## ORIGINATION FORM

Proposed Revisions to a Standard Plans Index  
(Please provide all information — Incomplete forms will be returned)

Index Number: 700-041  
Sheet Number (s): 2 of 5  
Index Title: Span Sign Structure

INDEX	SHEET
700-041	2 of 5

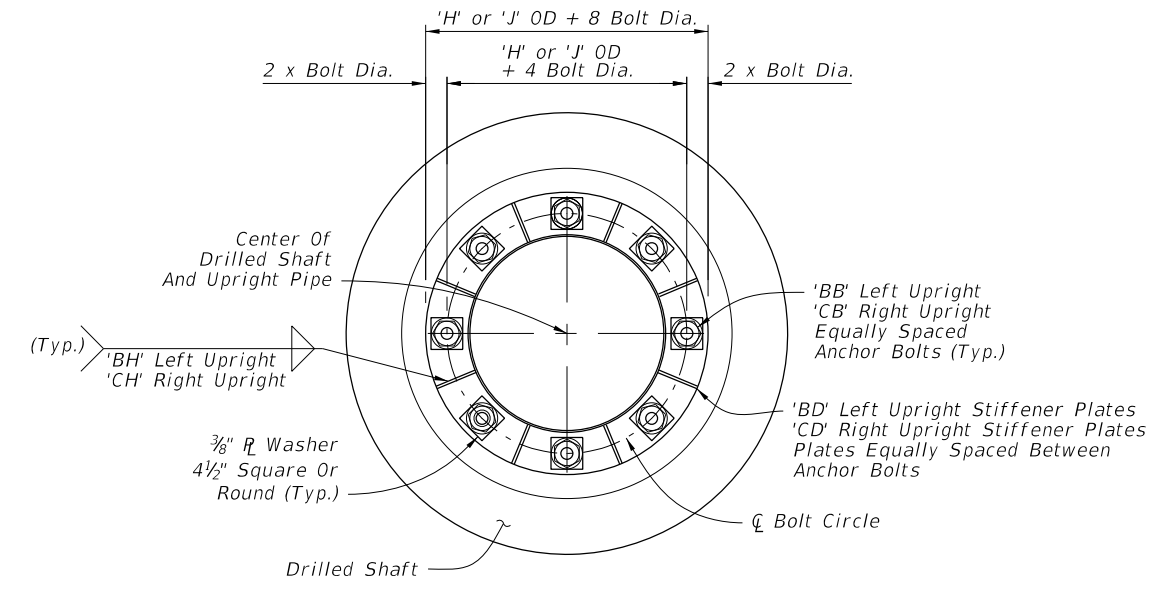
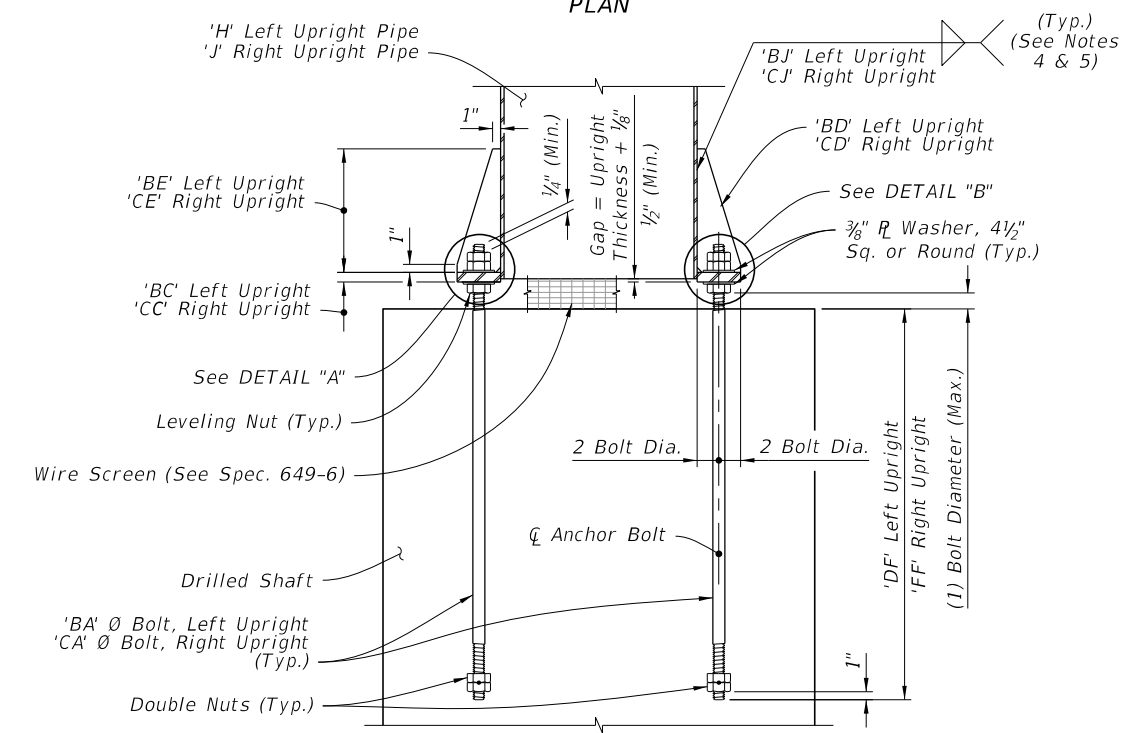
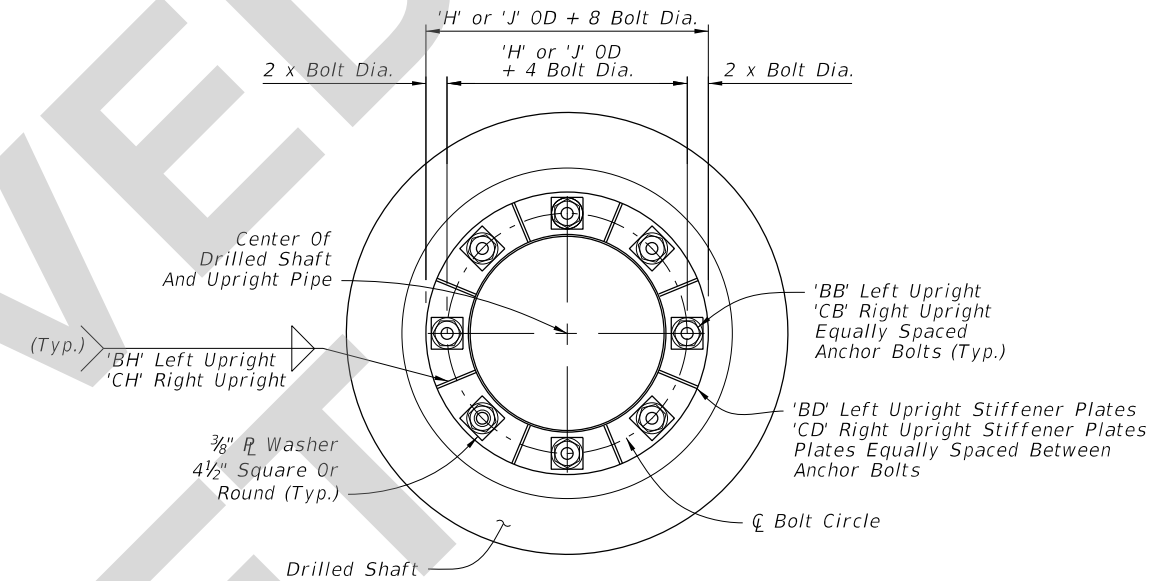
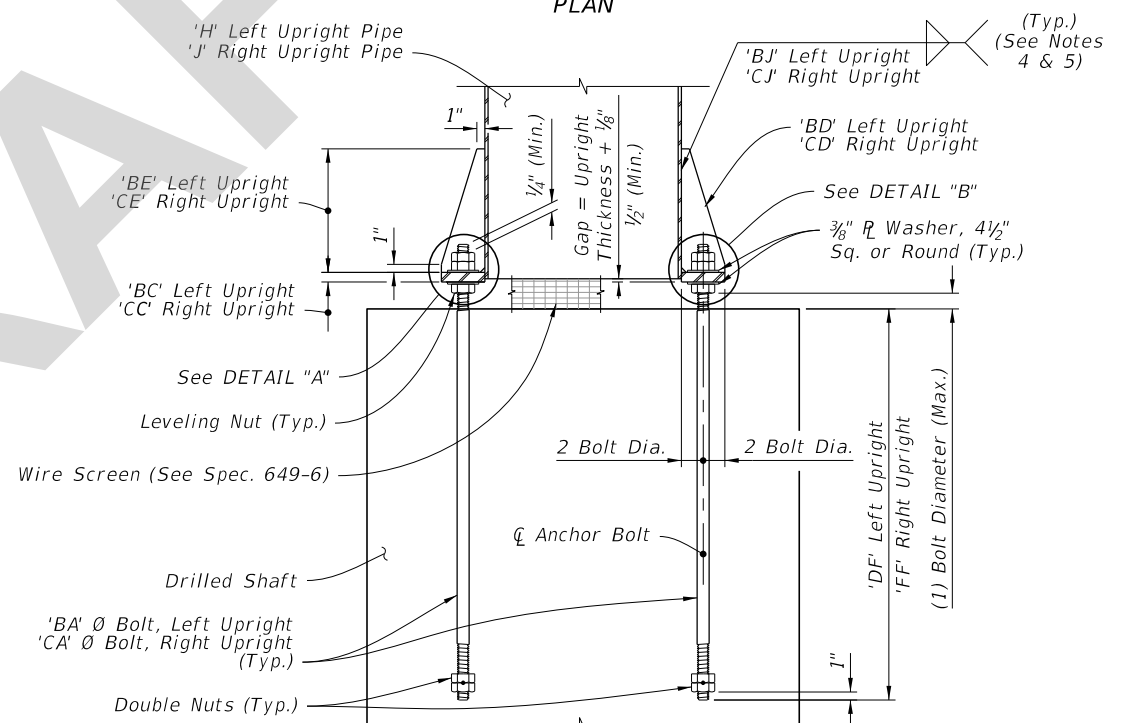
Revised Note 5 to read "After galvanizing, provide magnetic particle testing on 100% of upright fillet welds."

During maintenance inspections, weld cracks were found on in-service overhead sign structure supports. A FDOT investigation determined the cracks were formed during fabrication. To implement a better fabrication quality control processes, the note on the Standard is being changed.

1. See Traffic Plans for elevation at top of Foundation.
2. Install Drilled Shaft with a 2'-0" minimum from top elevation of the drill shaft to the finished grade, unless specified otherwise in the plans.
3. The shaft length is based on 2'-0" height above finished grade.
4. Wrap fillet weld around the stiffener termination on the tube wall (Typ).
5. ~~Provide ultrasonic testing for Lamellar Tearing when wall thickness exceeds 1/2"~~

After galvanizing, provide magnetic particle testing on 100% of upright fillet welds.

- NOTES:**
1. See Traffic Plans for elevation at top of Foundation.
  2. Install Drilled Shaft with a 2'-0" minimum from top elevation of the drill shaft to the finished grade, unless specified otherwise in the plans.
  3. The shaft length is based on 2'-0" height above finished grade.
  4. Wrap fillet weld around the stiffener termination on the tube wall (Typ).
  5. After galvanizing, provide magnetic particle testing on 100% of upright fillet welds.
